# SERVICE C

PACKARD DIVISION

## Counselor

JULY, 1955

## Carburetor Throttle Control Shaft Lever Extension Kit

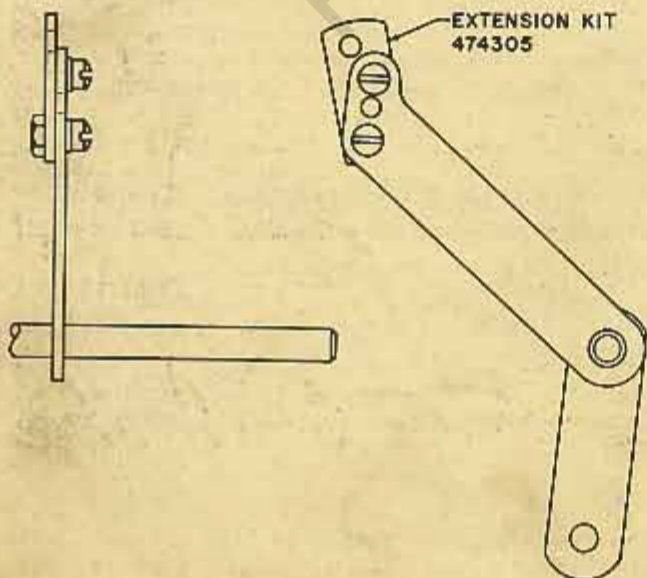
Unexpected or unwanted kick-down into low range converter when driving at full throttle or near full throttle position may be encountered in some 55th Series Twin Ultramatic Transmissions.

Because of the stack up of tolerances in throttle linkage and adjustments, throttle valve kick-down position is being reached before the carburetor throttle valves are fully open.

Therefore, to take care of the slight variations, the linkage geometry can be changed by installing

an extension on the throttle control cross shaft lever as shown in the illustration.

After installing the extension, readjust the linkage as described on pages 52 and 53 in the Twin Ultramatic Section of your new 55th Series Service Manual.

Part No. 474305 Carburetor Control Cross Shaft Lever Extension Kit is available through your Zone Warehouse.

Fig. 1

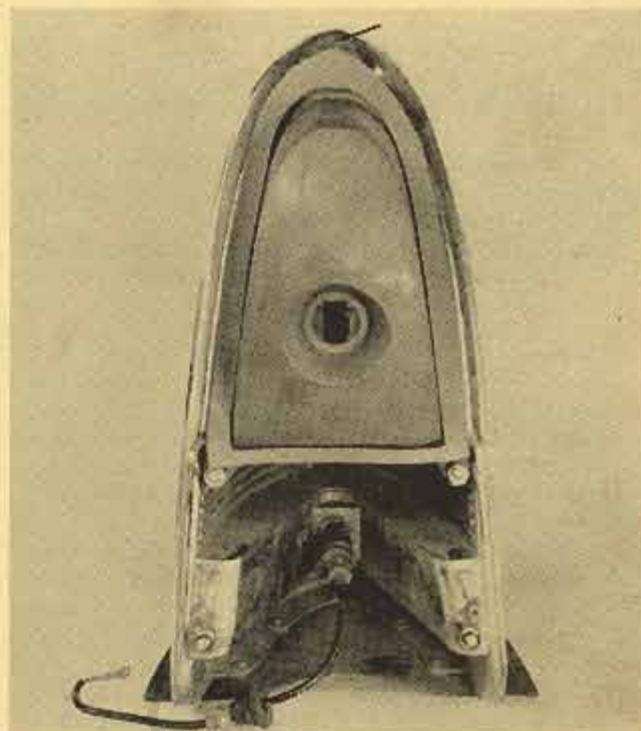
Illustrated in figure 1, is a new wider tail lamp body gasket for the 55th Series Packard models which will greatly reduce dust leaks in the trunk compartment.

1. Remove the lens retainer and lens from the tail lamp assembly. Fill the upper end of the lens center

chrome bar with dum-dum as indicated by the arrow in figure 1. Fill the bar slightly below the top edge of the lens to prevent dust from entering between the lens and the bar. Reinstall the lens and retainer and cement the new gasket to the retainer as shown. Pack some dum-dum around the threaded portion of the four studs.

Part No. 6480212, Lamp Rear Assembly to Fender Gasket, is available through your Zone Warehouse.

Fig. 2

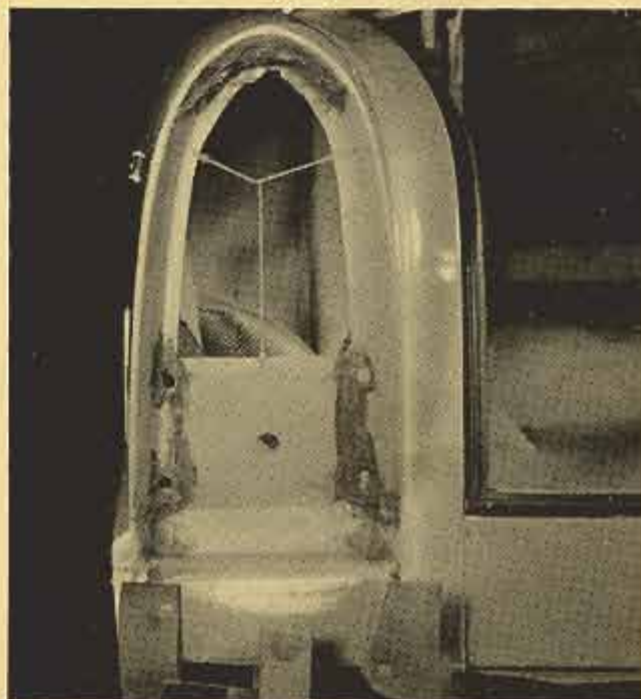
2. Make sure that the gasket seat flange is smooth and even, see arrow figure 2. Inspect the box section in the fender below the tail lamp opening for pin

holes and seal with dum-dum if necessary. Fill the upper flange of the fender with dum-dum as shown to form a tight seal when the lamp is installed.

Fill all edges of spot welding where pin holes might be found.

3. Place the lamp assembly in the fender and apply a wad of dum-dum over the studs before installing the cupped washers and retaining nuts.
